5090
Ser J00/010
February 22, 2023

SUBJECT: JTF-RH's Responses to DOH's Additional Requests for Information Regarding Red Hill Bulk Fuel Storage Facility Defueling Plan

JTF-RH Response to DOH Request for Information Regarding Red Hill Bulk Fuel Storage Facility Defueling Plan (January 13, 2023)

Release Event Tree Analysis
Various Failure Rate Scenario

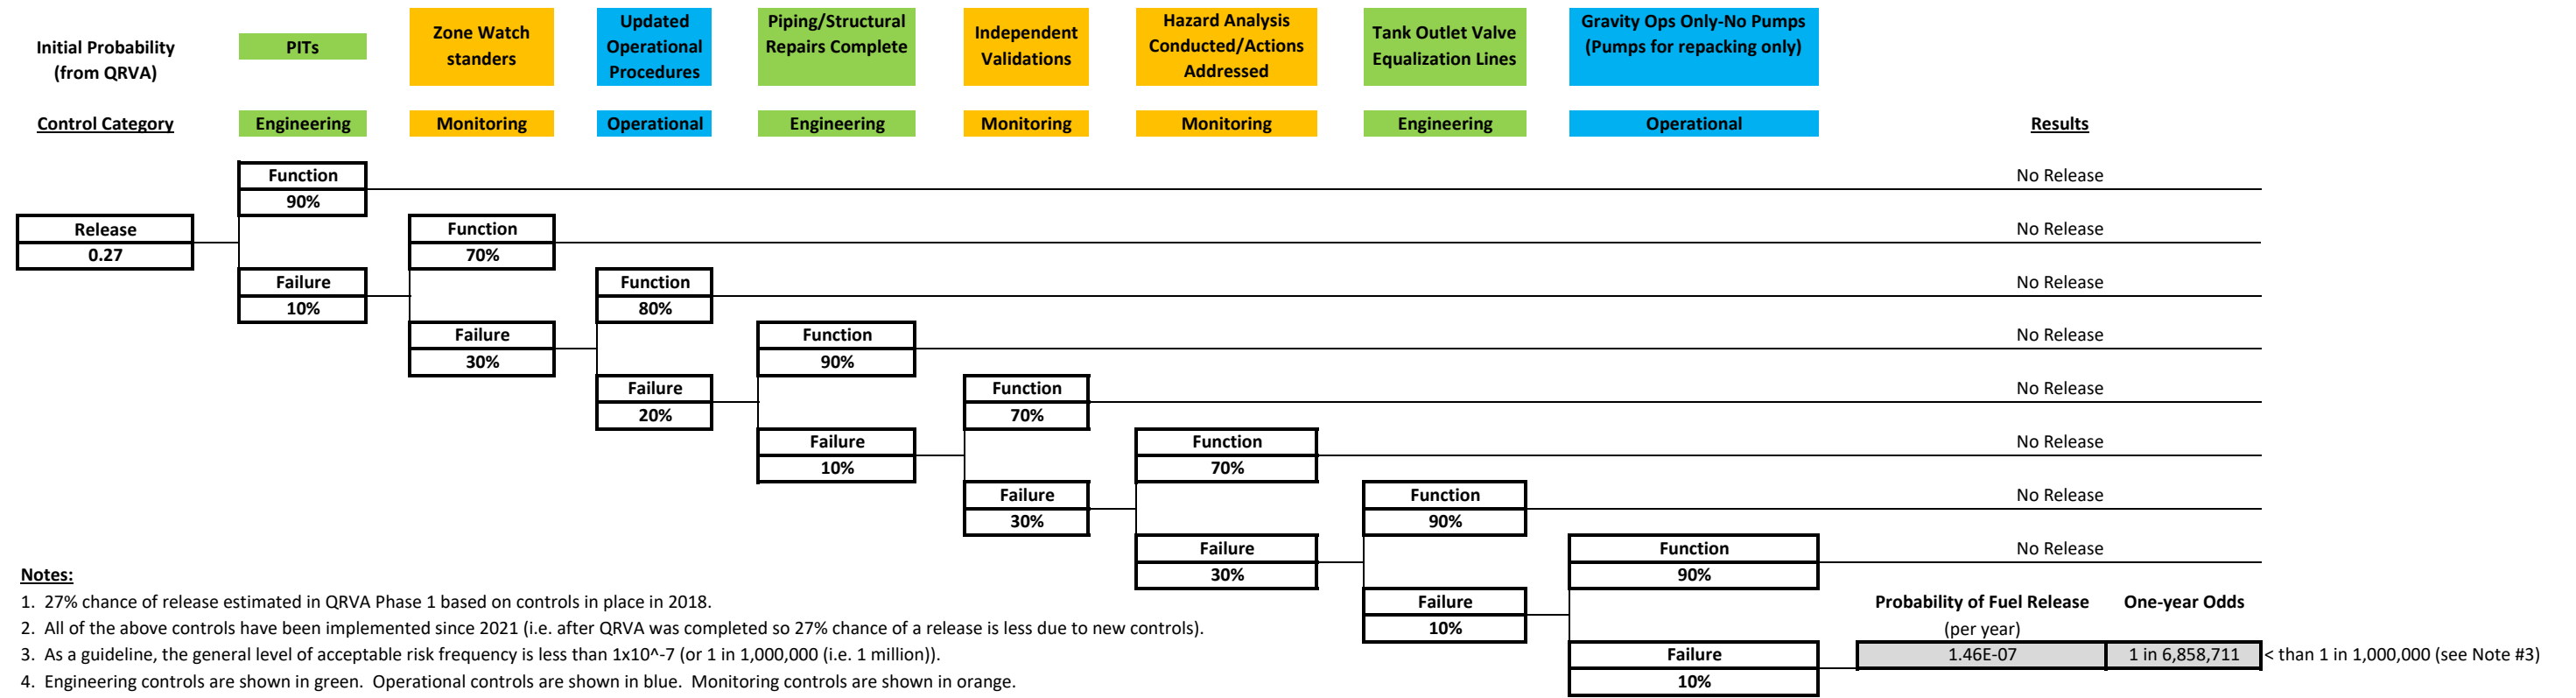
- i. Attachment 3 (event tree) shows the risk reducing from 9.89E-05 to 9.89E-06 through the box of "preventative barriers" (response to pressure indicating transmitters, watchstanders, and procedures) but does not explain how this reduction was derived (other than referencing the book used for layers of protection). Attachment 2, which appears to list items in this "box," contains some items that do not directly impact the environment, such as groundwater monitoring and the groundwater treatment system. By the time these items come into play, the environment has already been impacted. (However, we note some of these measures may prevent drinking water wells from being impacted after a release.)

- iii. There is no indication of how much, or if, items contribute to risk reduction, other than some general idea of a "layer," which is not defined in the response. To make the assessment easier to understand, the DOH recommends breaking risk into categories (e.g., physical repairs, updated operation procedures, added spill prevention, etc.) instead of layers.

Response: The updated risk assessment (see Reference (b)) addresses the inquiries above. Furthermore, additional coordination meetings between EPA, DOH, and JTF-RH on December 22, 2022 and January 13 and 20, 2023 were a collaborative and iterative process for development and clarification of the risk assessment.
